7 March 2025

Our Ref: P222_481-1 (ACCESS DA) DV

**ACCESSIBILITY CAPABILITY STATEMENT FOR SSDA SUBMISSION
PROJECT NAME: 3-5 HELP STREET, CHATSWOOD**

Drawing No.
 SSSA-1000

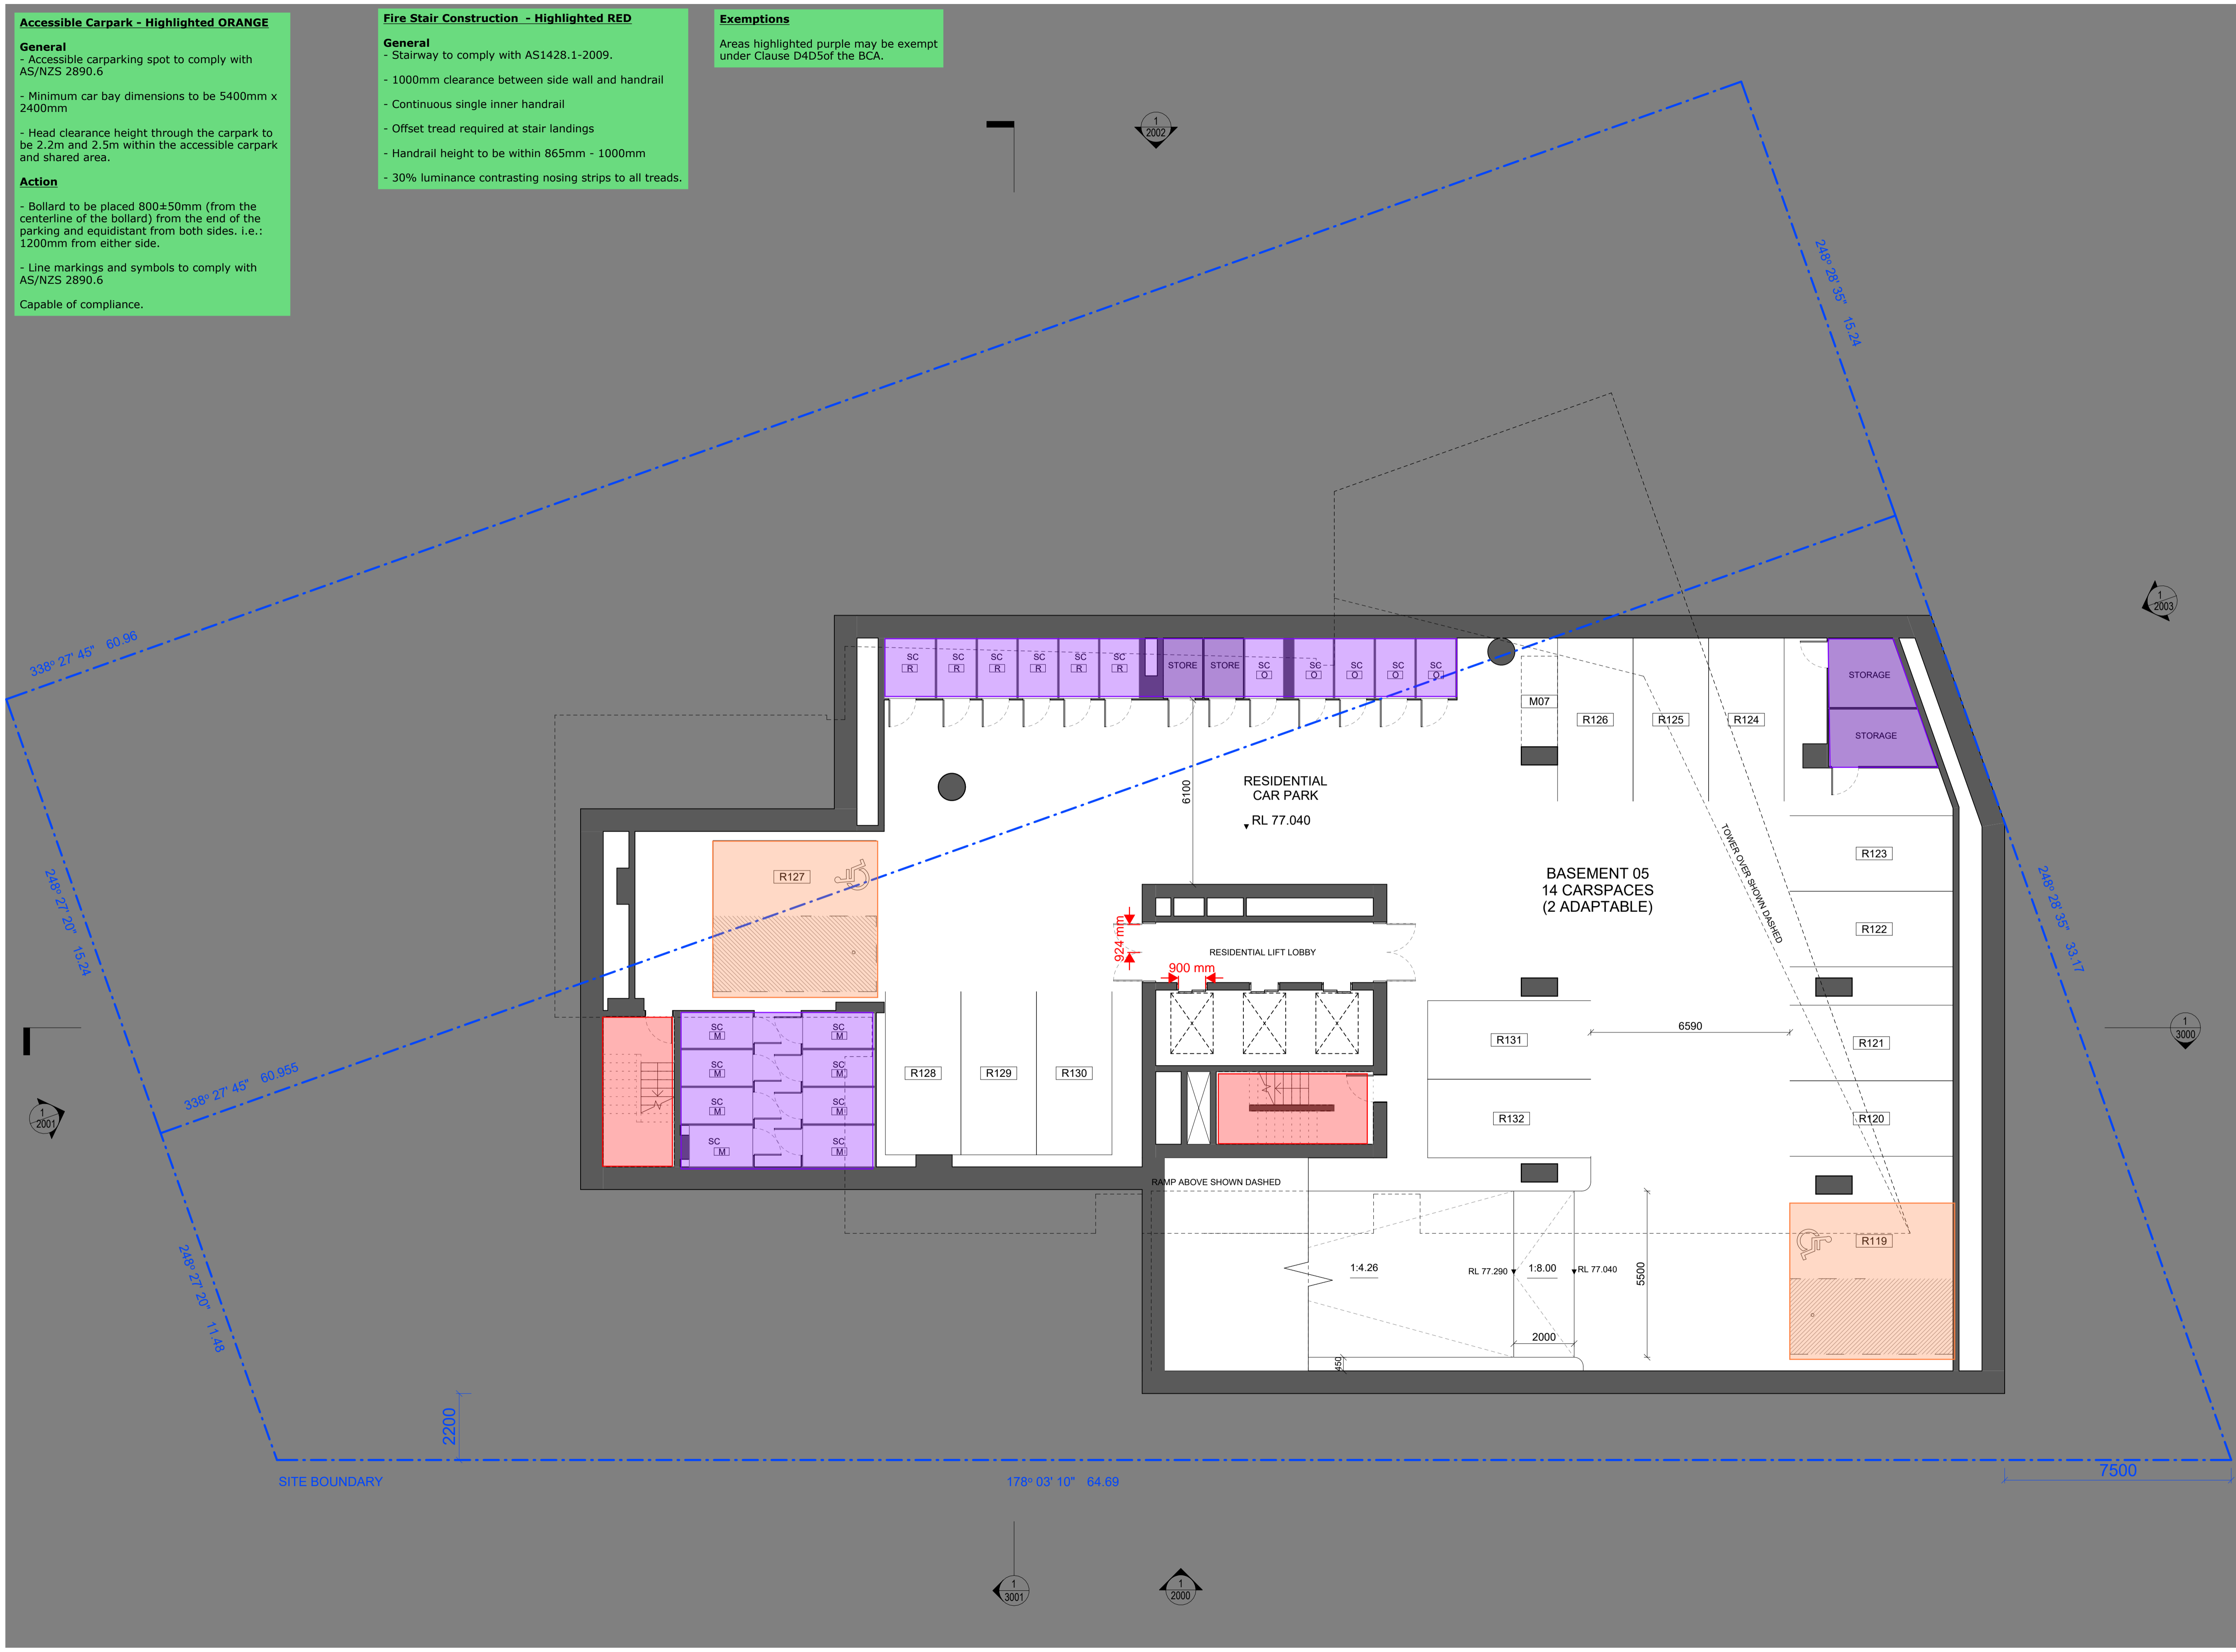
General
 - Accessible carparking spot to comply with AS/NZS 2890.6
 - Minimum car bay dimensions to be 5400mm x 2400mm
 - Head clearance height through the carpark to be 2.2m and 2.5m within the accessible carpark and shared area.

Action
 - Bollard to be placed 800±50mm (from the centerline of the bollard) from the end of the parking and equidistant from both sides. i.e.: 1200mm from either side.
 - Line markings and symbols to comply with AS/NZS 2890.6
 Capable of compliance.

General
 - Stairway to comply with AS1428.1-2009.
 - 1000mm clearance between side wall and handrail
 - Continuous single inner handrail
 - Offset tread required at stair landings
 - Handrail height to be within 865mm - 1000mm
 - 30% luminance contrasting nosing strips to all treads.

Drawing No.
 SSSA-1001

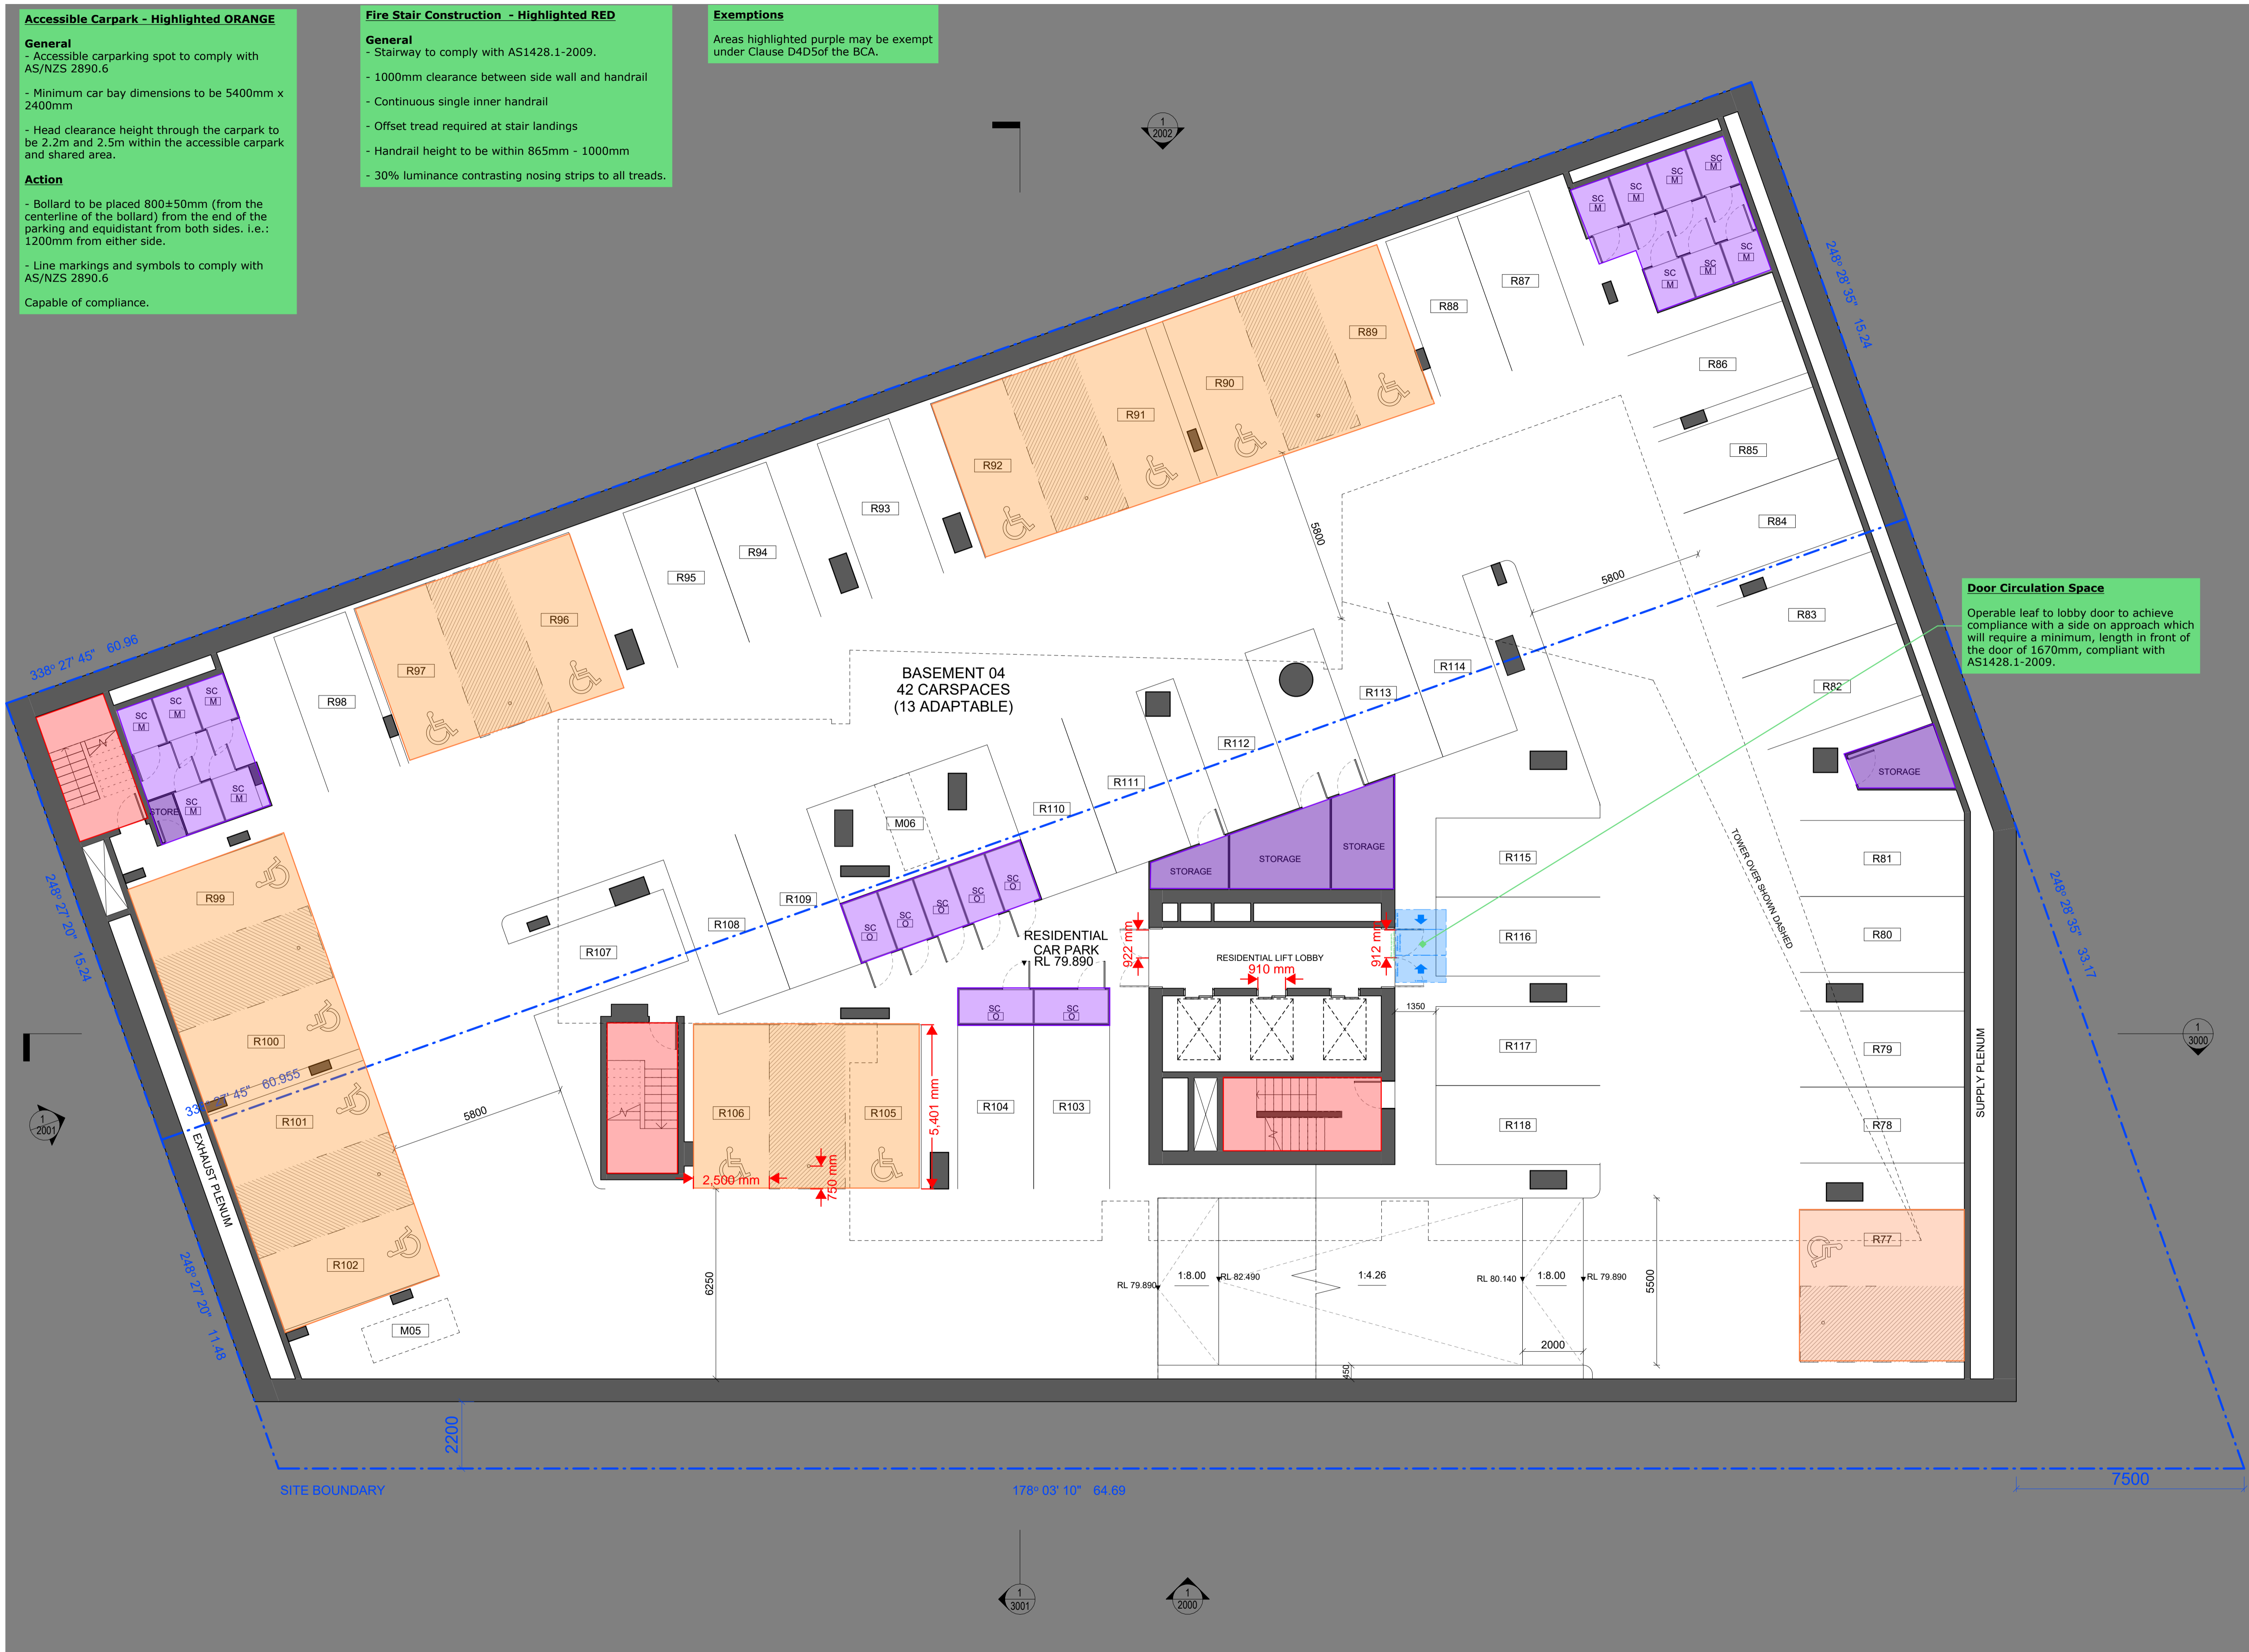
General
 - Accessible carparking spot to comply with AS/NZS 2890.6
 - Minimum car bay dimensions to be 5400mm x 2400mm
 - Head clearance height through the carpark to be 2.2m and 2.5m within the accessible carpark and shared area.

Action
 - Bollard to be placed 800±50mm (from the centerline of the bollard) from the end of the parking and equidistant from both sides. I.e.: 1200mm from either side.
 - Line markings and symbols to comply with AS/NZS 2890.6
 Capable of compliance.

General
 - Stairway to comply with AS1428.1-2009.
 - 1000mm clearance between side wall and handrail
 - Continuous single inner handrail
 - Offset tread required at stair landings
 - Handrail height to be within 865mm - 1000mm
 - 30% luminance contrasting nosing strips to all treads.

Operable leaf to lobby door to achieve compliance with a side on approach which will require a minimum length in front of the door of 1670mm, compliant with AS1428.1-2009.
